CITY OF LOS ANGELES

1911 W Sunset Bl DOT Case No. CEN 19-48428

Subject: TRANSPORTATION ASSESSMENT FOR THE PROPOSED MIXED-USE PROJECT LOCATED

AT 1911 WEST SUNSET BOULEVARD

CONCEPTUAL PROJECT SITE PLAN

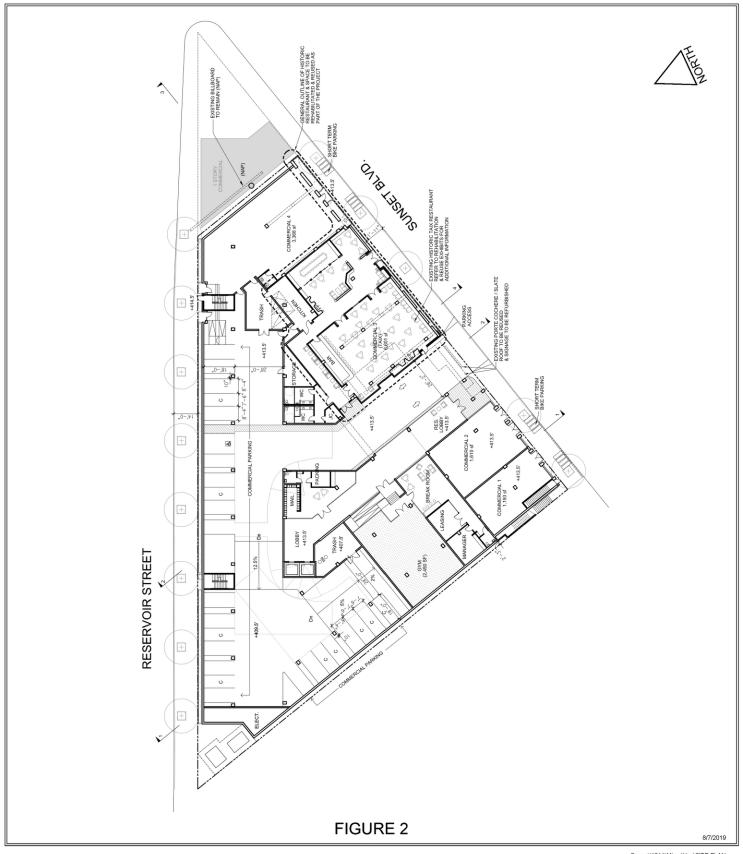
The conceptual site plan for the project (see **Attachment A**) is acceptable to DOT. The driveway on Sunset Boulevard would continue to serve the project site. Review of this study does not constitute approval of the dimensions for any new proposed driveway. Review and approval of the driveway should be coordinated with DOT's Citywide Planning Coordination Section (201 North Figueroa Street, 5th Floor, Room 550, at 213-482-7024). In order to minimize and prevent last minute building design changes, the applicant should contact DOT for driveway width and internal circulation requirements prior to the commencement of building or parking layout design.
